Memo

Proposed Development: Construction of a 38-level mixed use building comprising office, shop, civic space, office and hotel uses and an elevated public plaza, nomination of three (3) advertising signage zones with ancillary landscaping, solar photovoltaic panels and alterations to basement and public plaza

Subject Land: Festival Plaza

Subject: Applicant’s Response to Council Referral Response

ADELAIDE FESTIVAL PLAZA
TOWER 2 - BASEMENT LEVEL - B2
SWEEP PATH ANALYSIS
B99 CAR SWEEP PATHS

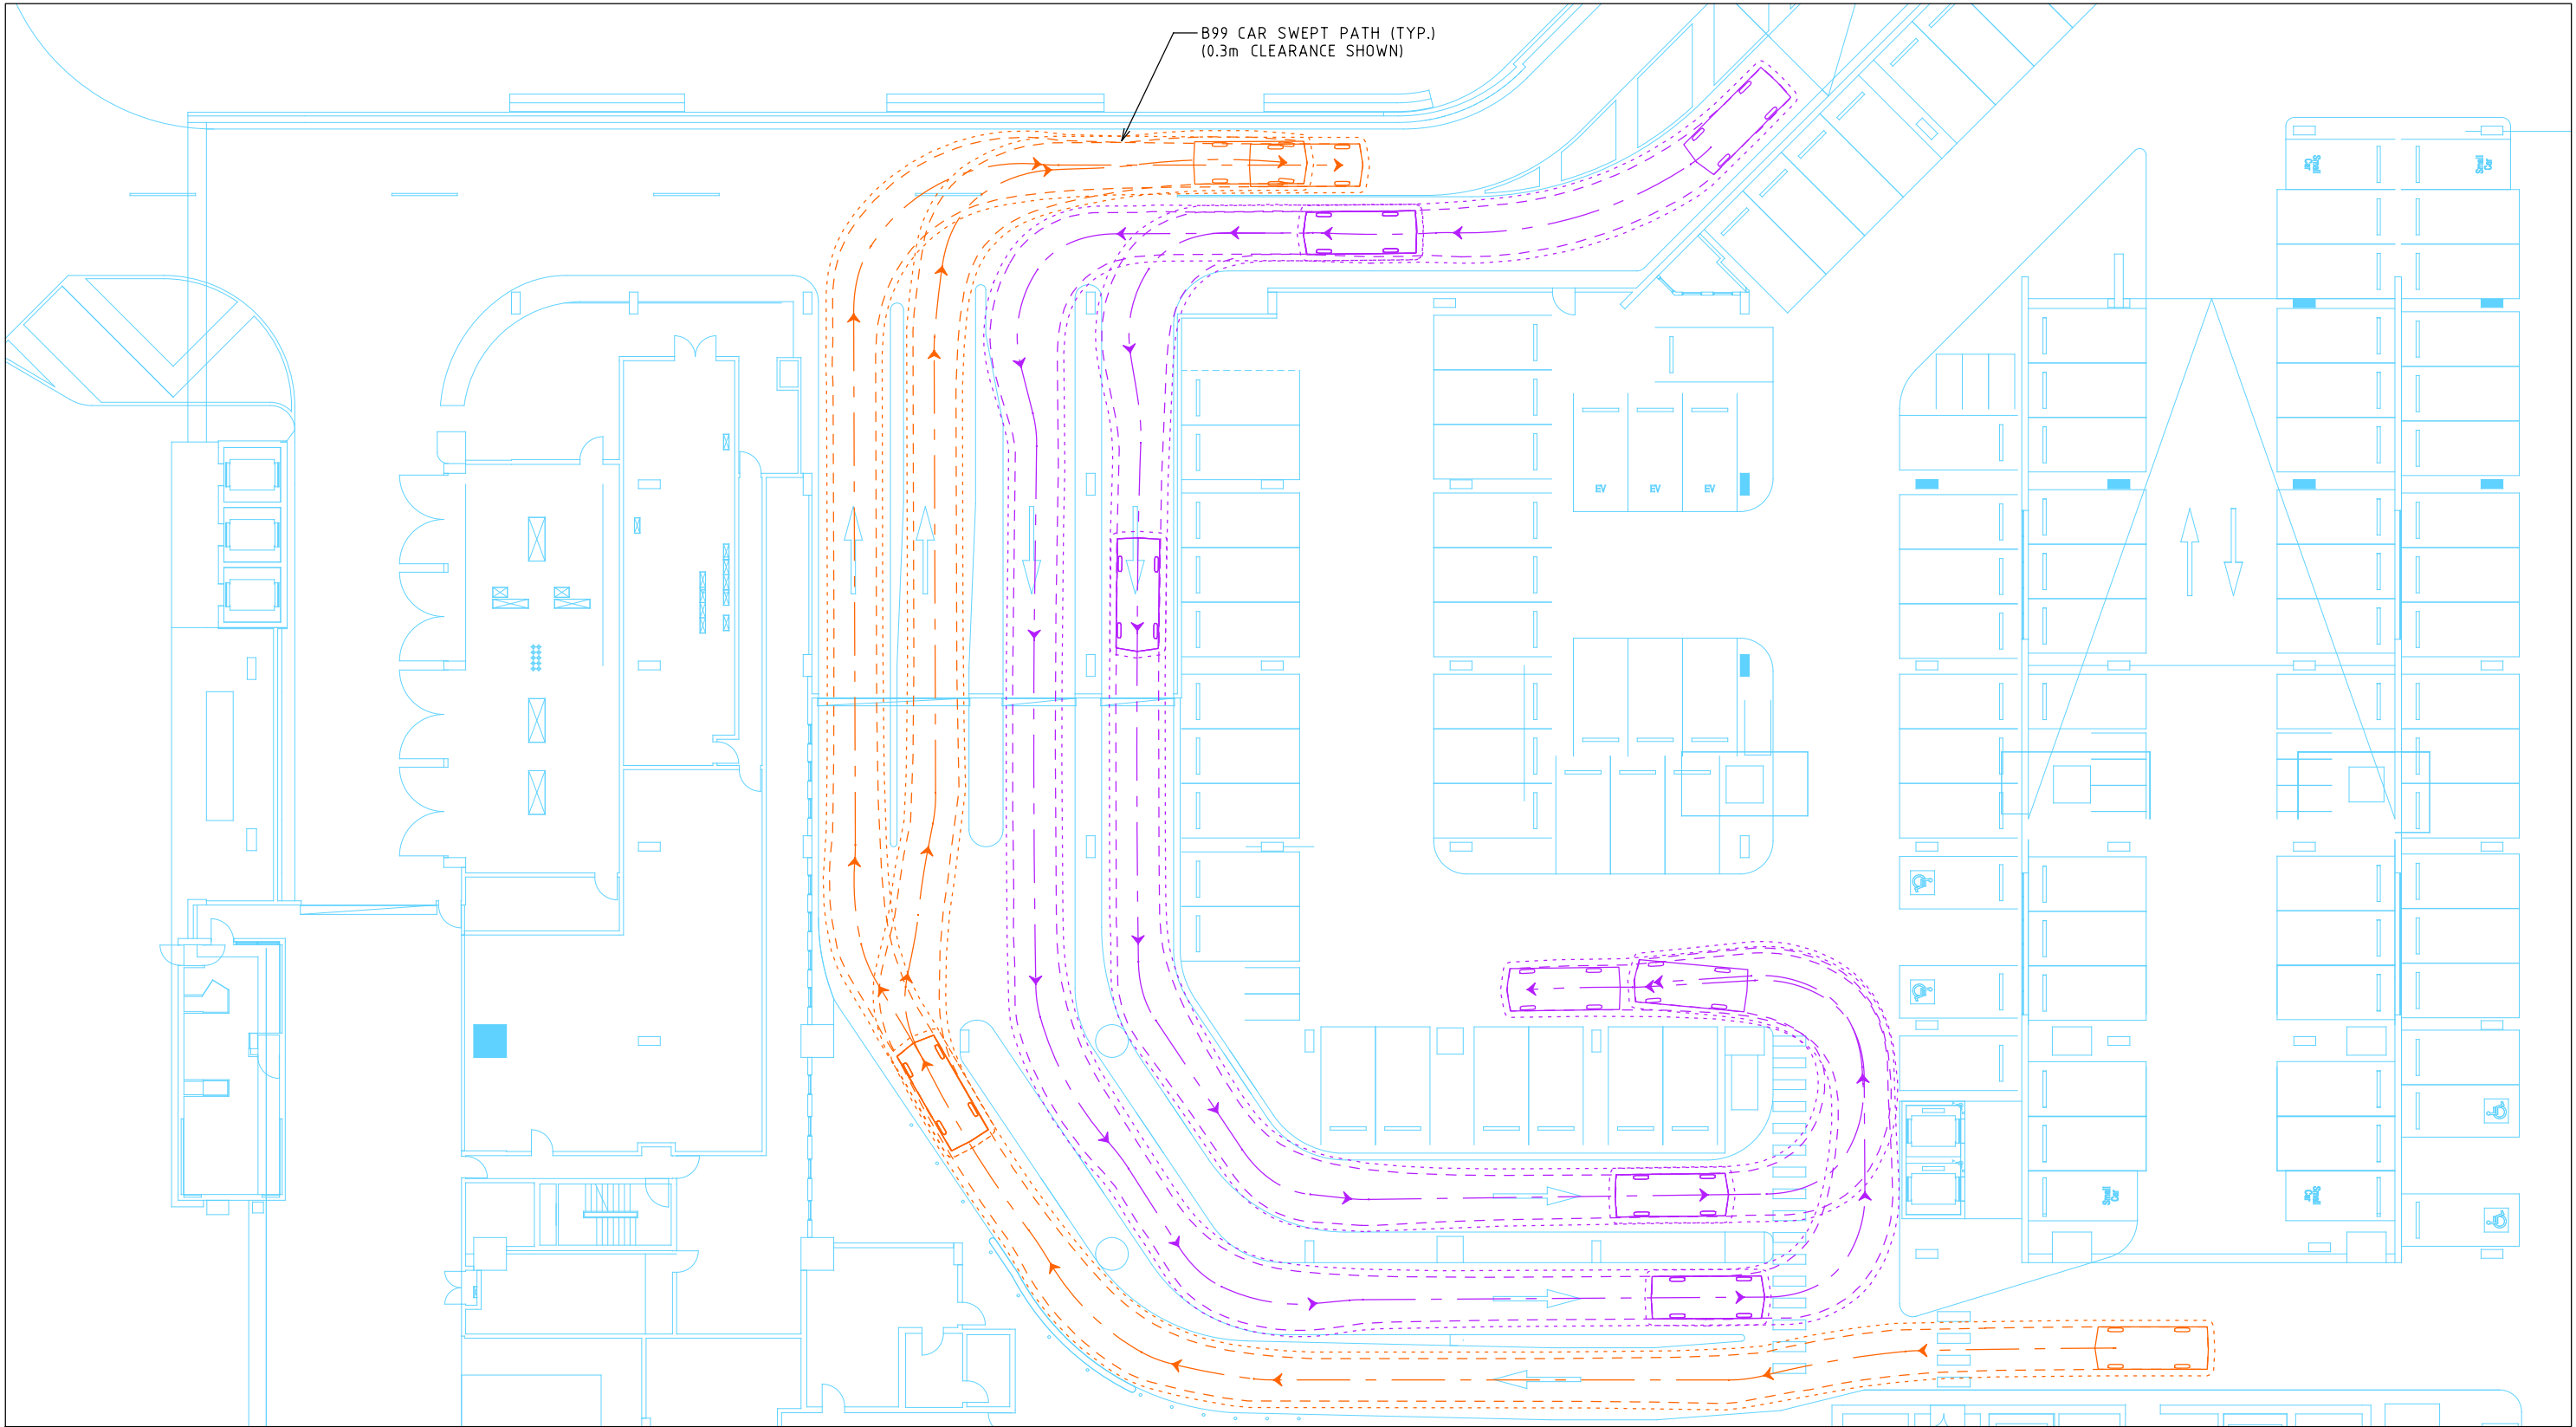
- Swept paths diagrams showing path of travel from public roads to parking spaces and loading areas should be provided.
- An assessment of proposed bicycle parking against the requirements of 'Table 3 – Off-Street Bicycle Parking Requirements' of the Code should be undertaken.
- The 14 accessible spaces proposed within a 1,354 space carpark should be increased.

WGA has prepared swept path plans for MRV and B99 vehicles demonstrating all vehicles will continue to be able to enter and exit in a forward motion (refer to **Appendix 2**). The swept path plans should be reviewed concurrently with WGA's 'Loading and Car Park Assessment' (*Appendix 10* to the original Planning Statement) which includes swept path plans for SRV and MRV vehicles entering and exiting the loading bays. The turnaround movements of vehicles will occur within the loading bay and not Festival Drive, minimising disruption to traffic flow.
